### Zero-degree drawer too cold

Due to the problems which have occurred with the zero-degree appliances, the factory has undertaken some modifications as of serial no. 422xxxxxx in order to solve these problems, which concern the excessively low temperature in the zero-degree compartments.

Illustration A

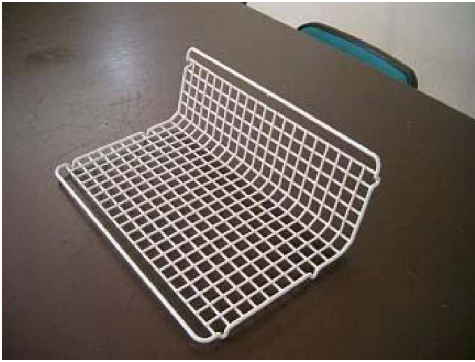
Quantity	Specification	Spare-part no.	Ill.
1	New display electronics	43 24 20	
1	Grid, soft wire, top drawer	43 24 21	A
1	Grid, soft wire, bottom drawer	43 24 22	B
1	Separator, soft wire, top drawer	43 24 23	C
1	Protective casing, air passage modified	43 24 24	D
1	Polystyrene screen modified	43 24 25	E

The former separator in the top drawer can no longer be used.
